N1092F-02

# Modification Available Performance Enhancement Service Note

# N1092E DCA-M Sampling Oscilloscope

An improved extinction ratio calibration is available for DCA-M Sampling Oscilloscopes with option 30A

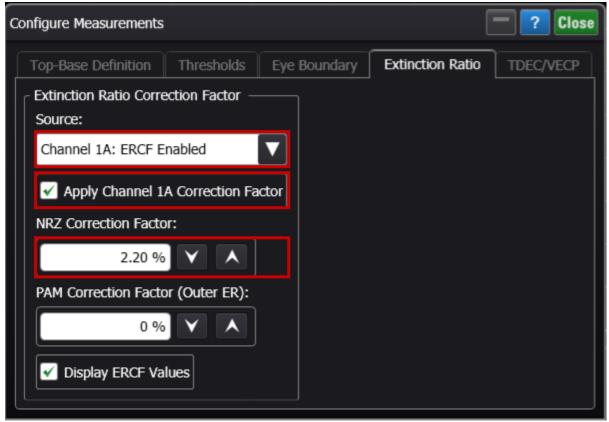
For N1092x DCA-M instruments with option 30A, units with the improved ER calibration are identified in the Help > About dialog with a "C1" annotation following the serial number.

- If the "C1" annotation is present, the unit has the improved ER calibration
- If the "C1" annotation is not present, the unit has the older ER calibration
